**Subject: Supplemental Preliminary Geotechnical Evaluation for Proposed Self Storage Development, 68<sup>th</sup> Street and I-15, APNs 152-020-010, 152-060-007 and 152-060-009, Jurupa Valley, California**

## **5.0 RESPONSE TO GEOTECHNICAL REVIEW COMMENTS**

Geotechnical review comments were provided by the City of Jurupa Valley (City, 2023) for the previous geotechnical reports for the project (LGC Geo-Environmental, 2020a & b). For your convenience, the pertinent review comments have been repeated below along with our geotechnical responses. A copy of the review sheet is provided in Appendix E.

**SHEET**  
**1 of 1**

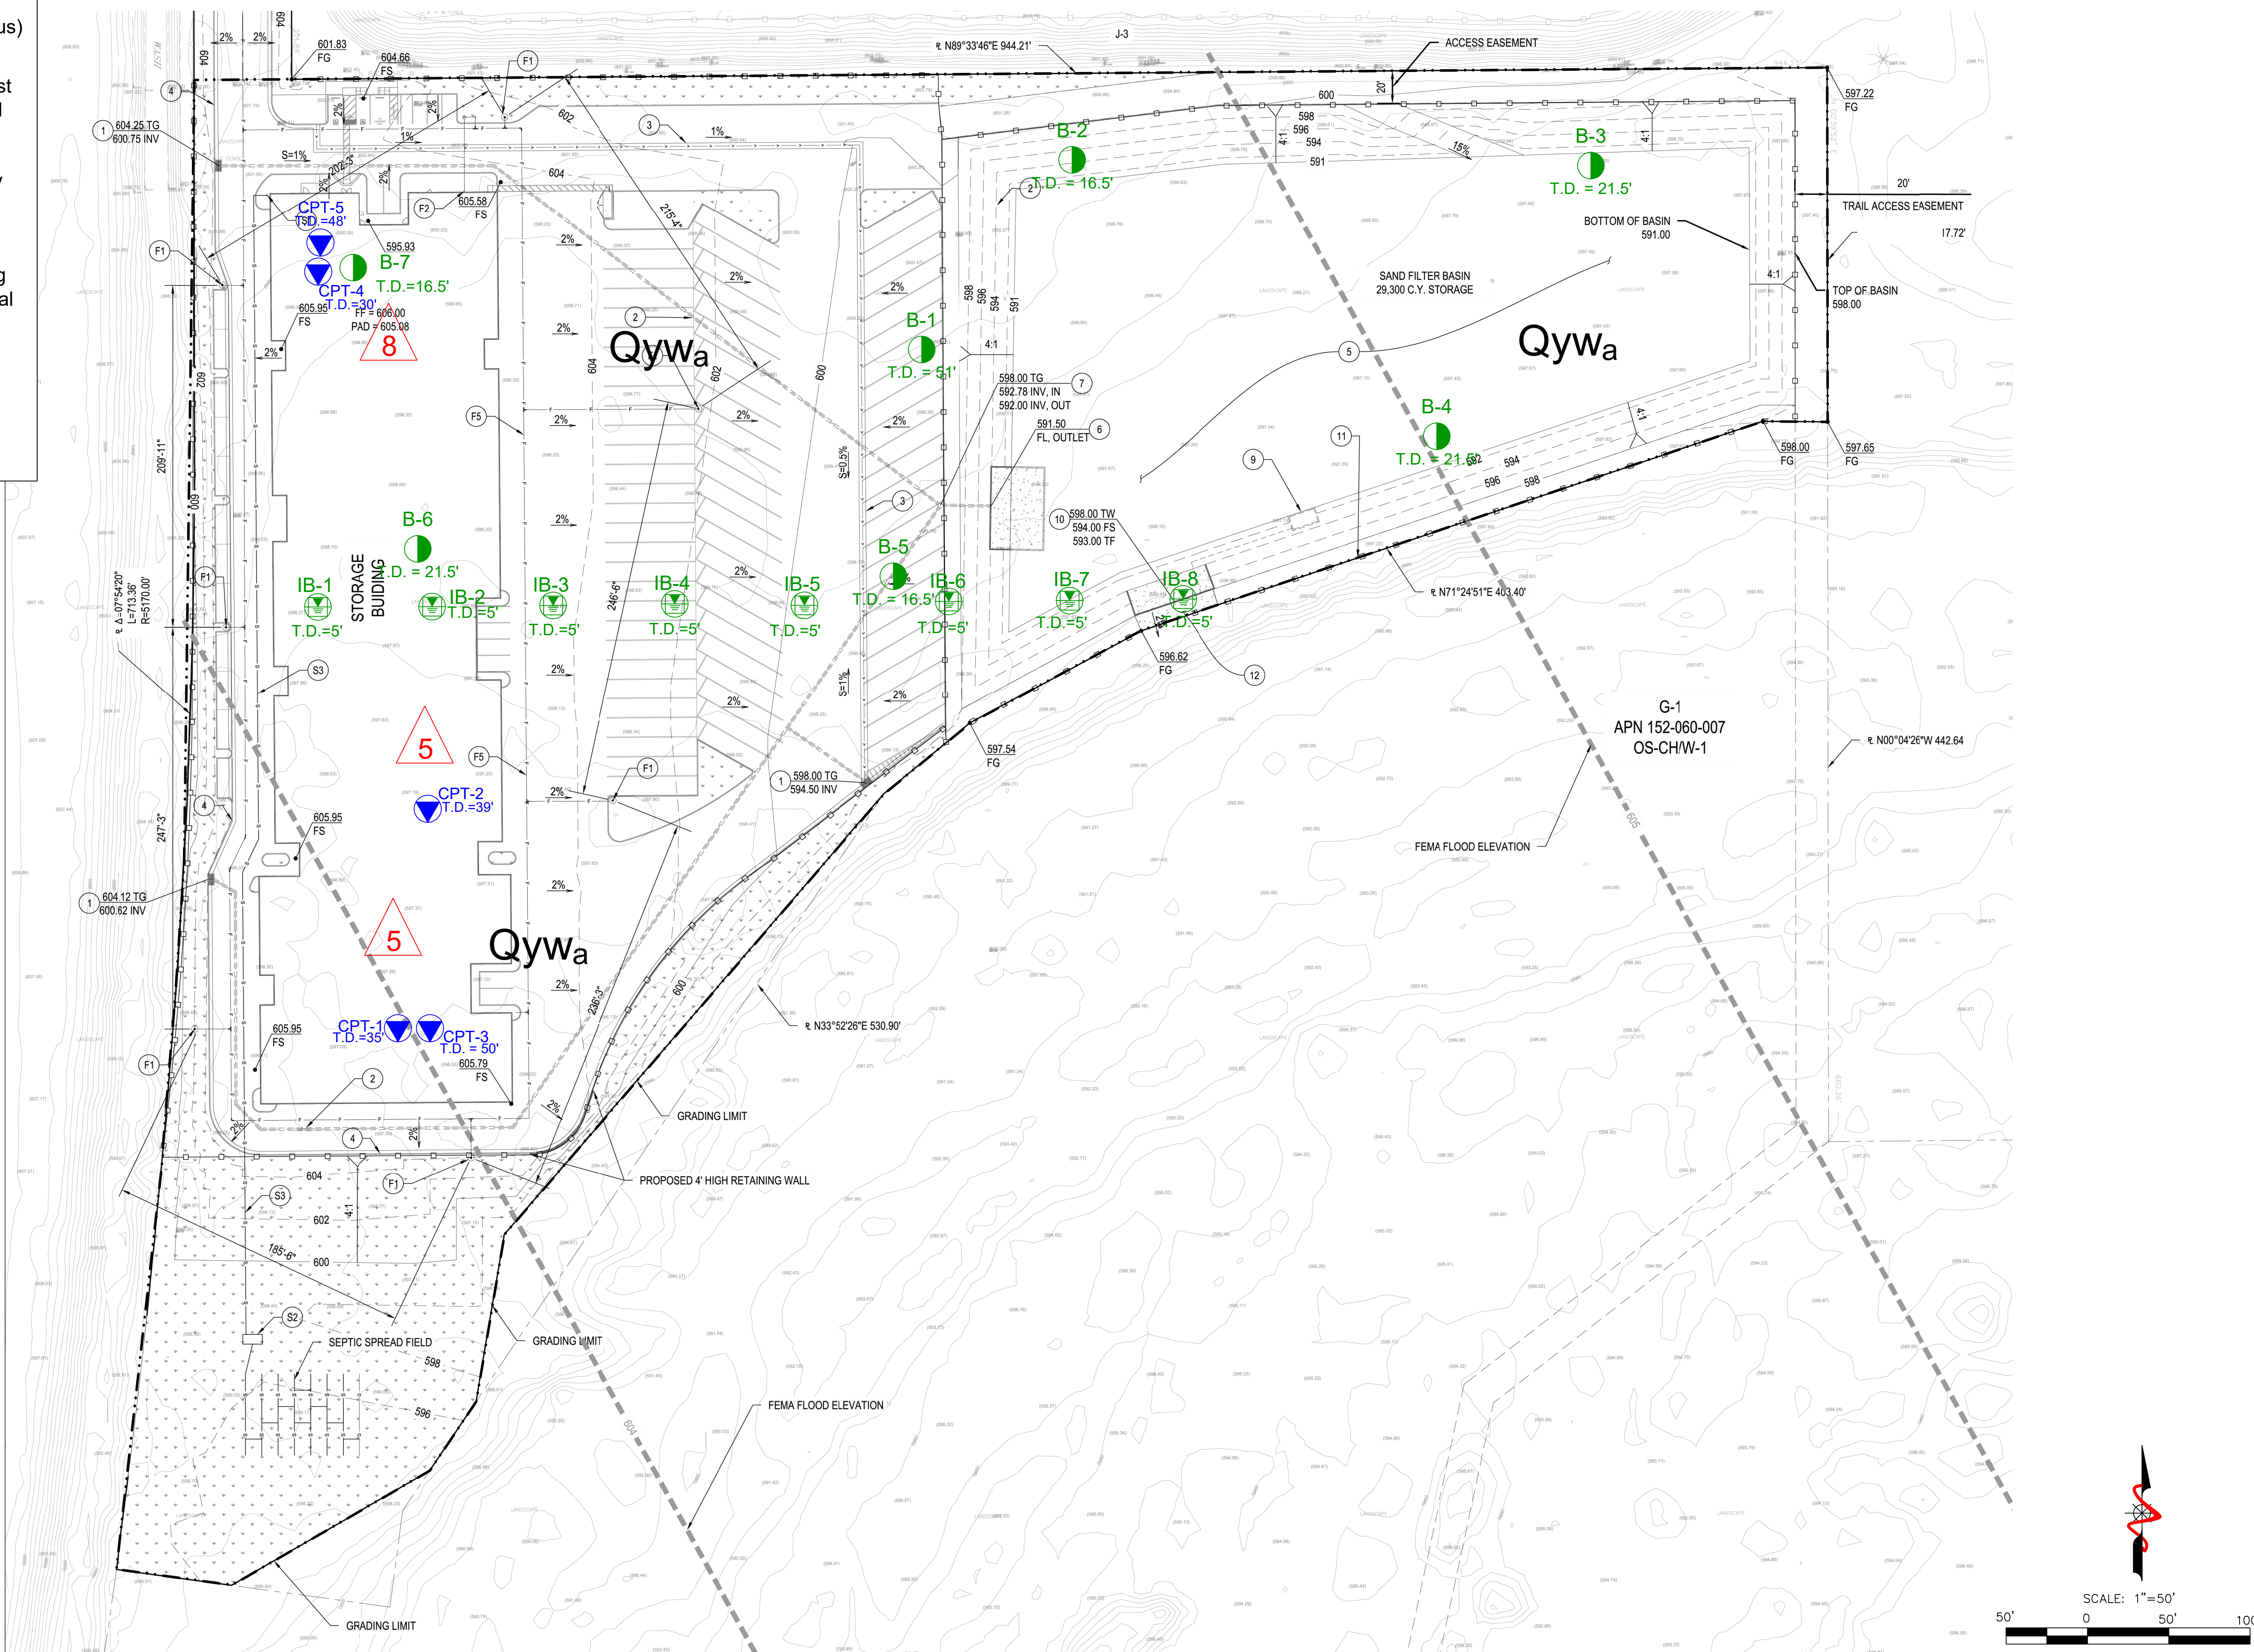
“The consultant should present the boring and infiltration test locations on a plan that uses the current grading plan as a base map.”

The location of our recently performed CPT soundings and the boring and infiltration tests performed by others are included on the Preliminary Geotechnical Map (Sheet 1) presented herein.
